# Application to AMEND a Planning Permit

Planning Permit No.: 12/0317

**RFI Request – Application No: 12/0317G**  
**40 The Esplanade, Torquay**

PROJECT TITLE:  
**PROPOSED RETAIL & RESIDENTIAL DEVELOPMENT**  
 AT:  
**40 THE ESPLANADE TORQUAY 3228**

**Figure D – Current placement of restaurant air-conditioning condensers which our client wishes to relocate in an effort to resolve any noise nuisance.**

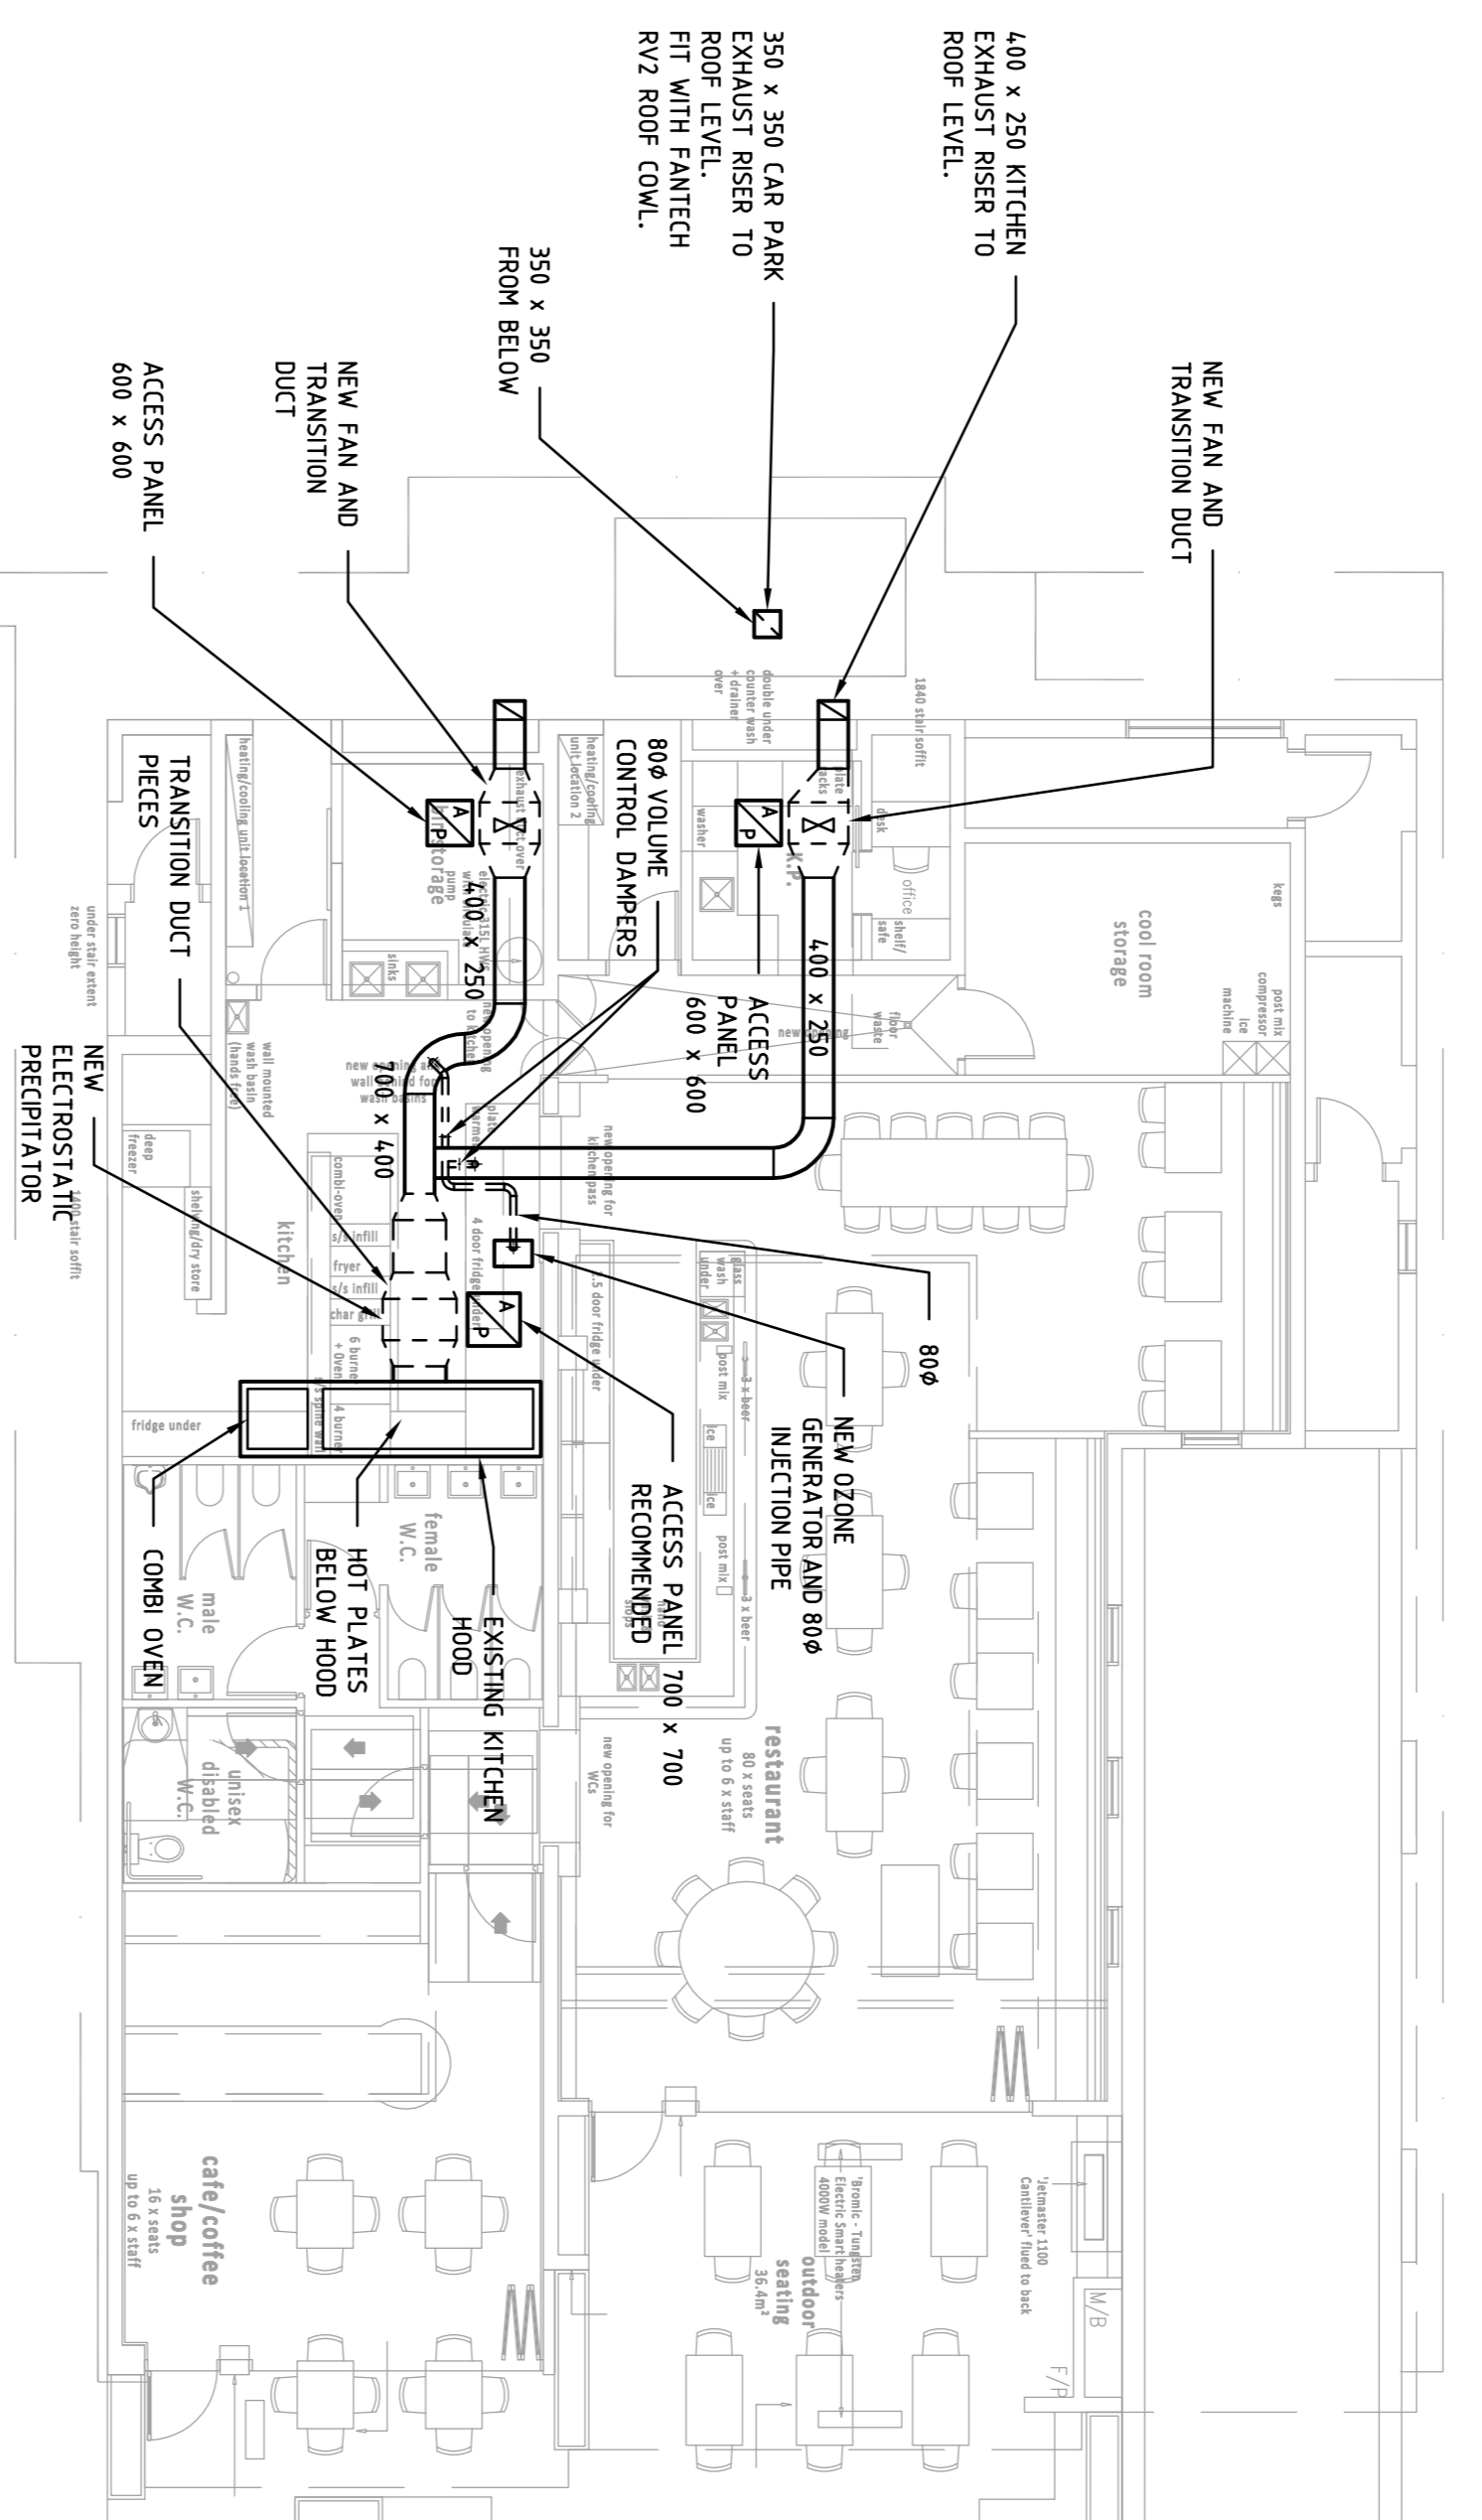
This report confirms SLR’s recommendations were to move the air-conditioning condensers as they may be the source of the noise nuisance these objectors are experiencing. **We submit that the only way to determine this properly is to carry out the independent full report suggested with these condensers switched completely off and operating also in isolation. Attached as Figure D is a photo of the current placement of those condensers for your reference.**
